# COUNTAX™

## SERVICE BULLETIN

15-09-14

MODELS: SCARIFIER

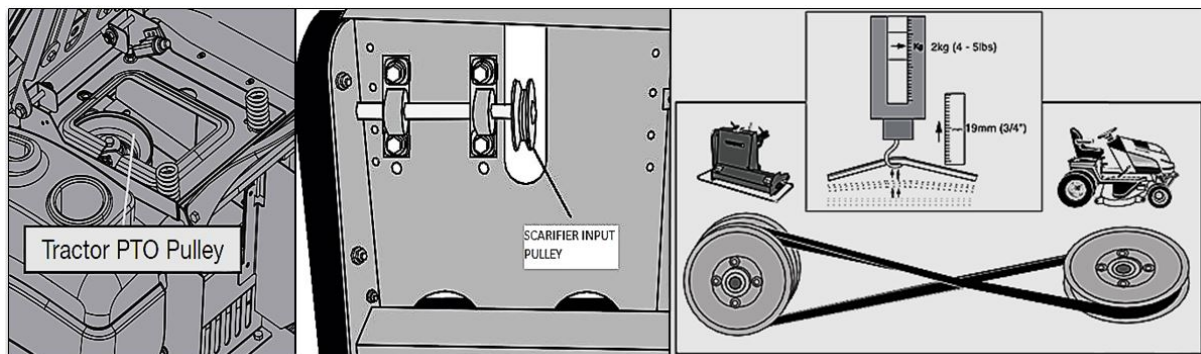
- Standard A56 Belt for MK4 B-series, C-series, F-series, T- series, A (415,416,418,416-4WD and 418-4WD) Mule, A25H, V25H, Park 250, A230D, V230D and Park 230 models.
- Additional belt option (A55 belt) for MK3 C500H, C600H, C800H, C600-4WD, C800-4WD, C25-4WD, S / T Series (S1350H, S1500H T1600H, T1800H, T1600-4WD, T1800-4WD & T25-4WD).

- New scarifiers will be supplied with an A56 belt and suitable for current production tractors only.

The new 2015 Guarded Scarifier will be supplied with an A56 drive belt which connects the tractor PTO to the Scarifier input pulley. This belt is incompatible with MK3 tractor models and will require an A55 belt in order to function as designed. The A55 belt is not supplied as standard and should be purchased as an addition at order stage if required.
